DA RESPONSE SUBMISSION

DA2021/2034
30 FAIRLIGHT STREET
FAIRLIGHT

RE: DA2021/2034 for 30 Fairlight Street, Fairlight
Submission providing Objections to the Proposed Development

FIGURE 1 – Massing comparison to previous DA 2020/2034. Loss of neighbour privacy.

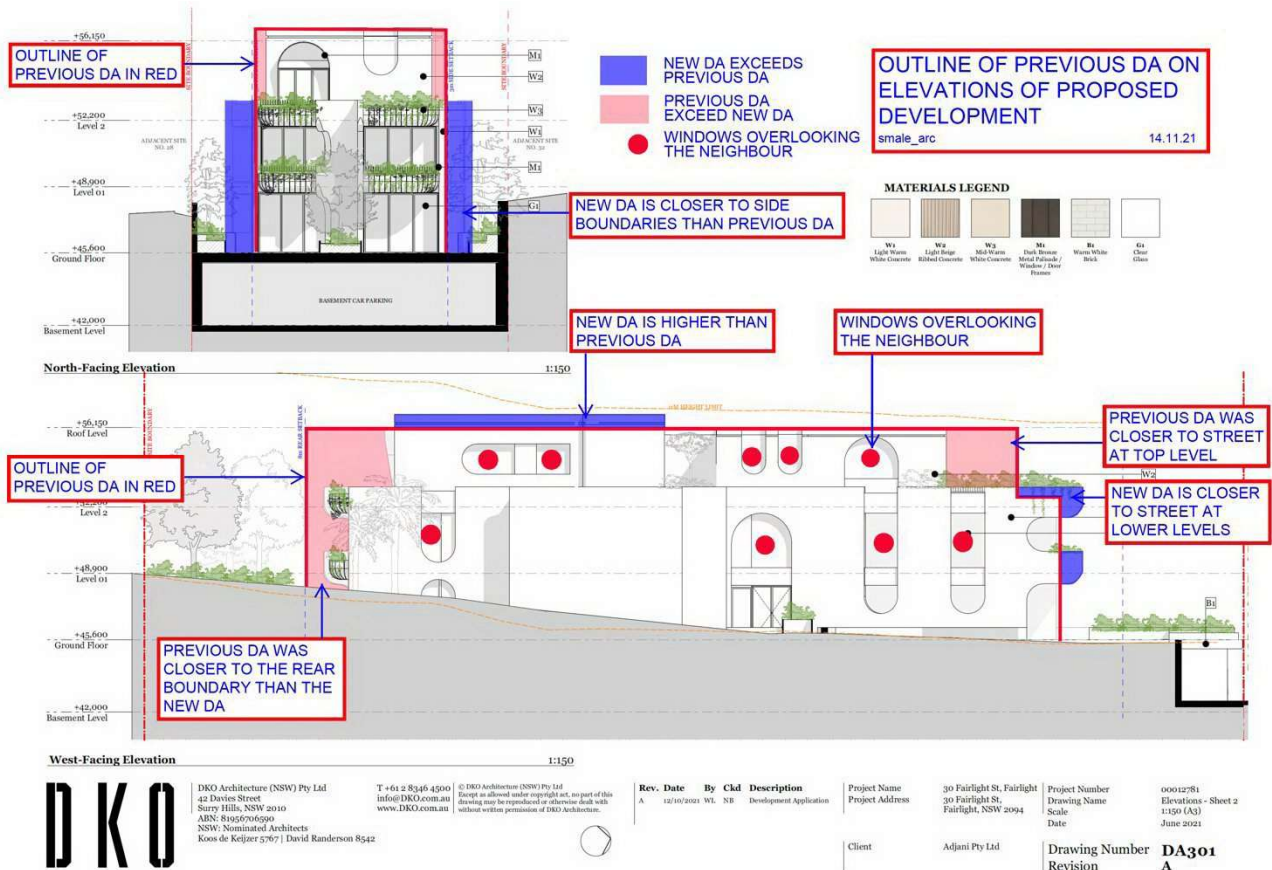
FIGURE 1 below overlays the outline in red of the previous DA onto the elevations of the new DA. It can be seen that the new DA substantially reduces the side boundary setbacks, is higher overall and is closer to the street frontage on all but the uppermost level. The previous DA was closer to the rear boundary.

For instance, Figure 1 above clearly shows that the units are so long that it is impossible to orientate each unit to Fairlight Street with all of the side boundary windows highlighted overlooking the neighbour with only 1 window/door per unit facing Fairlight Street. The reality is that the site, containing a single detached cottage is small and narrow. Accordingly, it is unreasonable to expect that it can be developed with the same intensity as for a larger site. This is only to be expected. Once the required setbacks are applied to any small site the proportion of land remaining for development is inevitably less than for a larger site. Refer FIGURE 2 below which uses nominal average ADG compliant setbacks. It is clear from this example that if 10 apartments (DCP compliant) are compliant for Site 2 then Site 1 can't possibly accommodate 5 very large 3 bedroom apartments in the area available.

FIGURE 3 – Apartment Design Guide Section 3F Figures 3F.2 and 3F.3

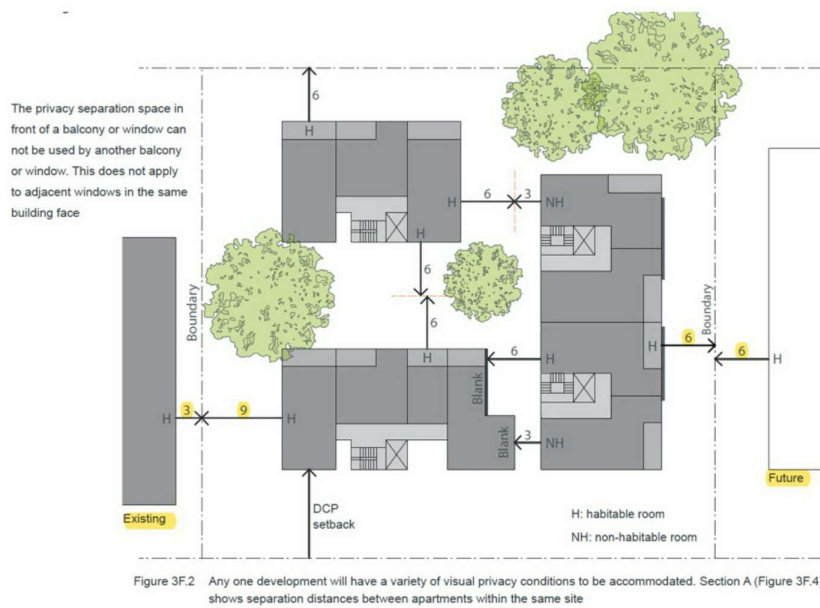
Reference	ADG Requirement	Claimed Compliance	Assessed Compliance Comment
Orientation	Buildings define Street. Limit overshadowing of neighbouring properties	Yes	Non-compliant. Refer Figure 3 and ADG building separation requirements analysis above. The excessive building bulk pursued does no limit overshadowing of neighbouring properties and would inhibit future adjacent development at 32 Fairlight Street. The non-compliant nil setback does not respond to the desired character of the street.
Deep Soil Zone	7% of site area	Yes	Non-compliant. The presence of a 2m high retaining wall and associated footing through the middle of the deep soil zone will reduce deep soil zone to about 4%
Visual Privacy	Separation between non habitable rooms and boundary of 3m. Separation of habitable rooms and boundaries of 6m. 12m separation between habitable rooms. Ensure separation and privacy between...windows and habitable rooms.	Intent of controls achieved.	Non-compliant. Reference to FIGURE 3 from the ADG shows the intent of controls. The proposed setbacks to habitable rooms from the boundary vary between 2 and 3.8 metres. It has been clearly demonstrated above that the ADG requirements of 6 metres <u>boundary separation</u> to future developments and 9 metres to existing developments (house at 32 Fairlight is set back 3m) are not met. The disparity is so great that the <u>intent of the controls cannot be met.</u>

FIGURE 4 – Roof Height/Envelope and Setback Study

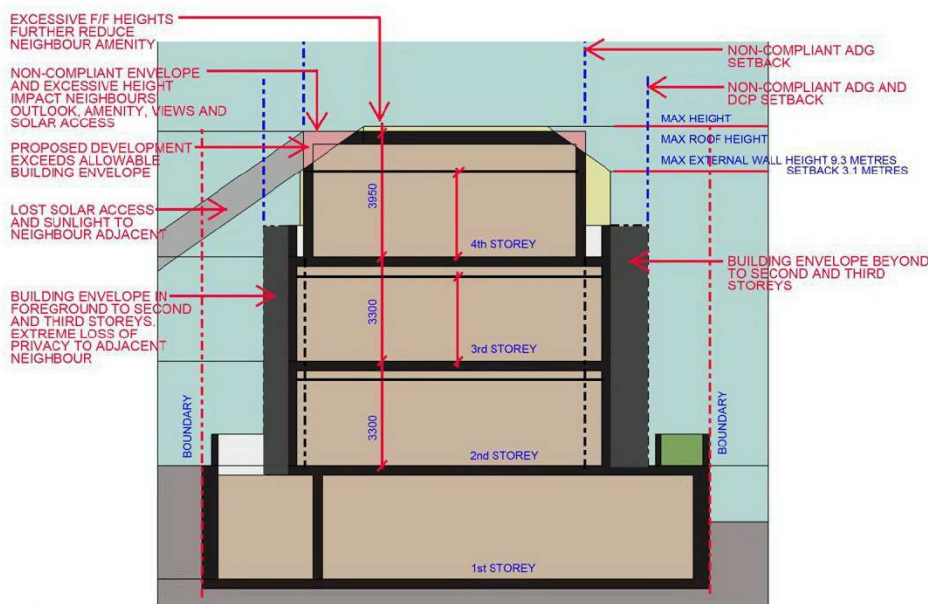
<ul style="list-style-type: none"> - The applicant has only measured the external wall heights for Levels Ground and Level 1 and has incorrectly omitted the top level. The actual external wall heights are 11 metres (E) AND 10.7 metres (W) not the 8.85 and 7.7 quoted. - The proposed flat roof projects through the allowable maximum sloping roof envelope and is therefore non-compliant. - The effect of this non-compliance is to increase overshadowing of the neighbours, disrupt outlook of rear neighbours, increase visual bulk in the streetscape and generally reduce amenity to the surrounding properties

FIGURE 5 – Solar Access impacts on Dwelling at 32 Fairlight Street – Less than 2 hours received

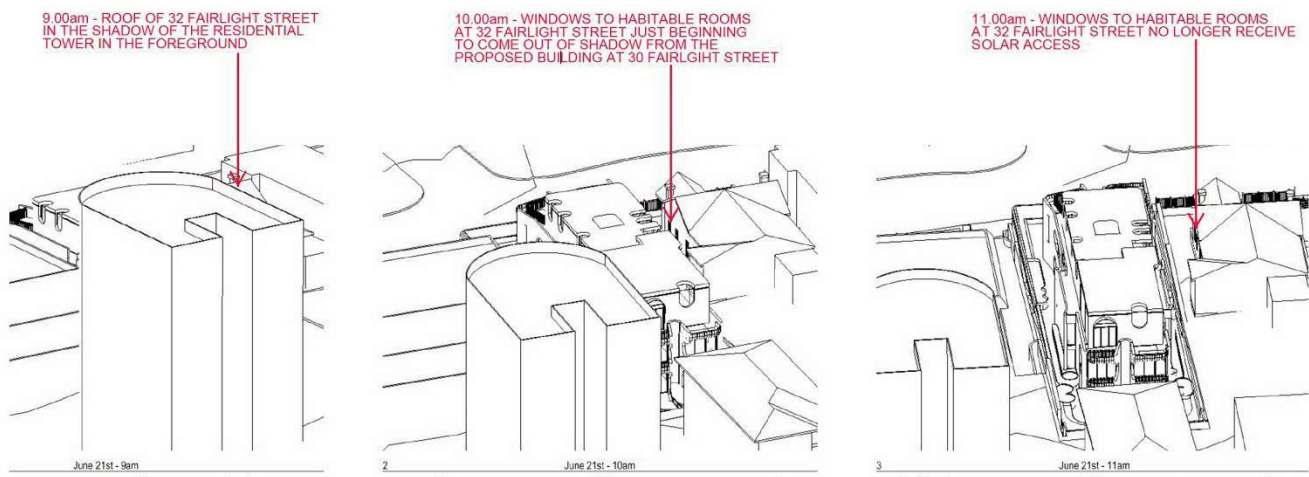
<p>30 Fairlight not to be developed to the detriment of 32 Fairlight</p>	<p><i>Note particularly, that the east facing habitable rooms of 32 Fairlight receive only 1 hour of solar access. Under Clause 3.4.1.2(c), for all adjacent buildings, no reduction in solar access is permitted to any window where existing windows enjoy less than the minimum number of sunlight hours specified (ie. 2 hours). Reference to applicants drawing DA500 'Eye of the Sun' shows that at 9am the subject windows are shaded by the residential tower in the foreground. By 10am the windows are just starting to receive solar access after being in the shadow of the proposed development. By 11am sunlight does not penetrate the windows. The development on 30 Fairlight must be designed to not reduce solar access to 32 Fairlight Street. Refer FIGURE 5 below.</i></p> <p>The excessive resultant bulk does not minimise view disruption and view loss from adjacent/nearby properties. Further evidence of lack of provision for view sharing by the applicant can be found in the design itself. The floor to floors of the building are exaggerated and exceed what is necessary to comfortably achieve 2700 ceiling heights. The floor to floor heights for the 2 lower levels are 3.3 metres, 600mm than the required ceiling height. The top floor has a floor to roof dimension of 3.95 metres which far exceeds what is necessary for a 2700 ceiling. The building could be nearly 1 metre lower with no impacts on the residents but a dramatic improvement on the impact on my amenity and views as well as those of my neighbours.</p> <p>Finally, there has been no consideration of the impact on a future adjacent development at 32 Fairlight Street (future Manly residents). The many non-compliances at 30 Fairlight <u>will inhibit development on the neighbouring site</u> and result in significant view loss to those future residents (due to non-complying setbacks and excess FSR at 30 Fairlight) as well as loss of general amenity including overshadowing, crowding, solar access and privacy. <u>The proposal is not an equitable development of the site and will diminish the value of 32 Fairlight Street.</u></p> <p>Alternatively, if the proposed development was replicated at 32 Fairlight Street the building separation for habitable windows to 30 Fairlight Street will be 4-5 metres and for 34 Fairlight Street 5-6 metres. This compares with a current minimum separation between apartments in the same Fairlight Street block of 9.3 metres against an ADG Section 3F requirement of 12 metres. <u>Not only would the amenity of residents in both buildings be severely impacted but the surrounding neighbours will experience further degradation of amenity, privacy and view sharing.</u></p> <p>The proposed development is demonstrably excessive and should not be approved.</p>
